Ref. Planning Application: 25/00826/FUL

Fanellan Substation- Construction and operation of a 400 kV Substation and Converter Station and Associated Infrastructure, Site Access, Landscaping and Demolition Works | Land 300M NW of Fanellan Farmhouse, Kiltarlity.

Figure 1. Allordale Received Spectra and Hearing Threshold

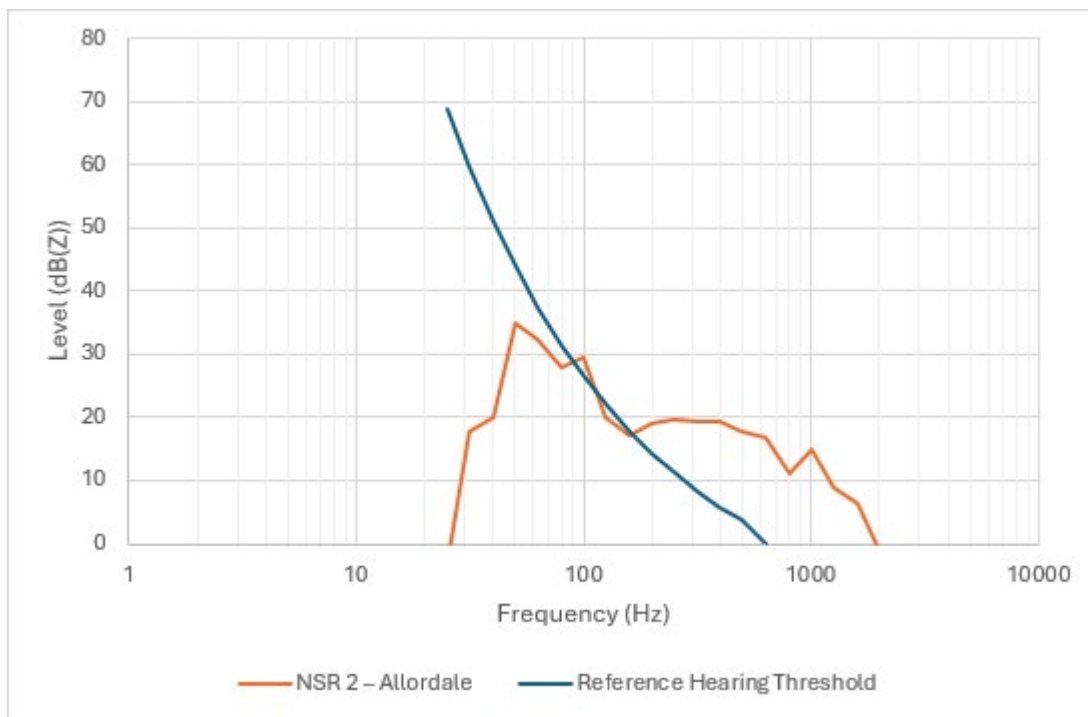
For additional context, the NSR at which noise is predicted to be the highest (Allordale), the more prominent third-octave band levels (50 Hz) are below the reference hearing threshold (Figure 1) and would not result in a tonal penalty when considered against the objective 1/3 octave band assessment described in BS 4142.

The comparison of Allordale spectra to the hearing threshold shows the 4 dB tonal penalty is conservative.
